# Access Compliance Report

## Public Rights-of-Way

Intersection ID: 42934	Main Street: HOLLY PARK DR	Cross Street: BALLINA WY	Location: S
ADA ID: D9B93F7228CB	Ramp Type: BlendTrans1	Initial Pass/Fail: Fail	Overall Compliance: No
Severity Score: 33.75			
Codes/Mitigation Info/Possible Solution		Field Measurements/Component Compliance

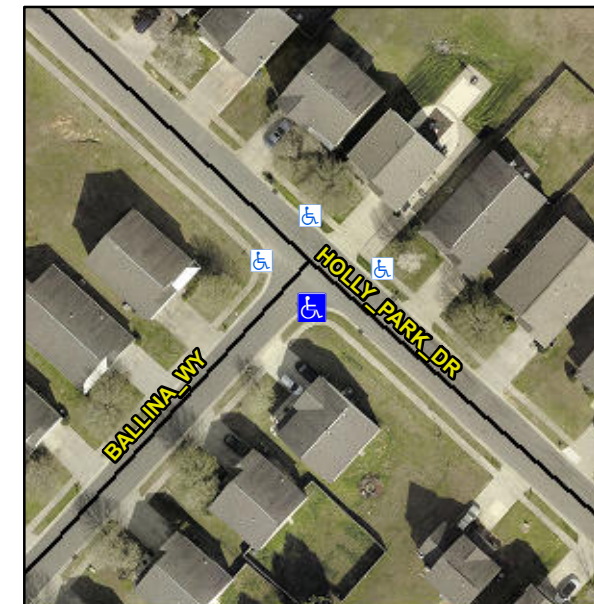
**Not Found, R304.5.1, R304.5.3**

Compliance	Description	Data	Compliance	Description	Data
N/A	Ramp Length (in)	48.0	Yes	BlendTrans Slope (%)	4.0
No	Ramp Width (in)	42.5	No	BlendTrans XSlope (%)	11.2
N/A	Flare Type LT	N/A	N/A	Flare Type RT	N/A
N/A	Flare Slope LT (%)	N/A	N/A	Flare Slope RT (%)	N/A
N/A	Flare Traversable LT?	N/A	N/A	Flare Traversable RT?	N/A
N/A	Landing Length (in)	N/A	N/A	DWS Provided?	N/A
N/A	Landing Width (in)	N/A	N/A	DWS Contrast?	N/A
N/A	Landing Slope (%)	N/A	N/A	DWS Length (in)	N/A
N/A	Landing X Slope (%)	N/A	N/A	DWS Full Width?	N/A
N/A	Landing Curb? (Y/N)	N/A	N/A	DWS Offset (in)	N/A
N/A	Shared Landing?	N/A			
N/A	Gutter Ponding?	N/A	N/A	Gutter Slope (%)	N/A
N/A	Gutter Lip Ht (in)	N/A	N/A	Gutter X Slope (%)	N/A
N/A	Painted X Walk1?	No	N/A	Painted X Walk2?	No
	X Walk 1 Direction	To NE		X Walk 2 Direction	To NW
	X Walk 1 Width (in)	N/A		X Walk 2 Width (in)	N/A
	X Walk 1 Slope (%)	5.2		X Walk 2 Slope (%)	5.7
	X Walk 1 X Slope (%)	7.6		X Walk 2 X Slope (%)	6.8

**Remove & Replace Curb Ramp With Two New Directional Ramps or Equivalent.**
